Ref Document – EB0003 issue 01
Date 24-6-04

PRODUCT SAFETY BULLETIN

ZF Steer Axle

PJB Minecruiser, Mk 4.5

Photo 1

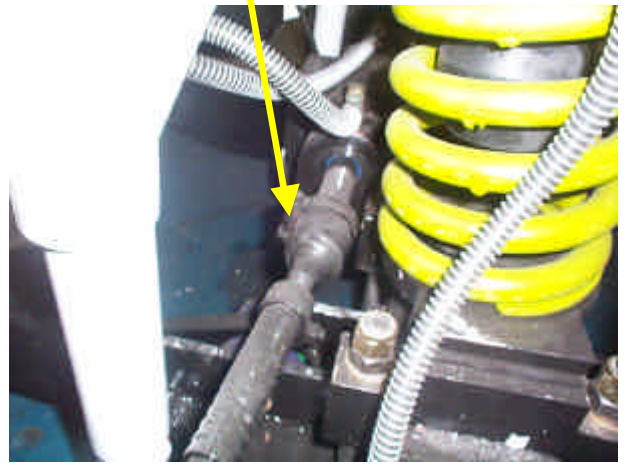
A replacement steering link had been incorrectly fitted to a Mk4.5 Minecruiser steer axle by others. The link had been fitted such that the clamp near the ball joint rubber cover was rotated 180° from its normal position allowing it to contact the axle mounting saddle and hence restrict the steering angle of the axle on that side.

All Minecruisers fitted with ZF steer axles should be inspected to confirm correct fitment of the steering joint clamp. The incorrect fitment is shown in Photo 1 while the correct arrangement is shown in photo 2.
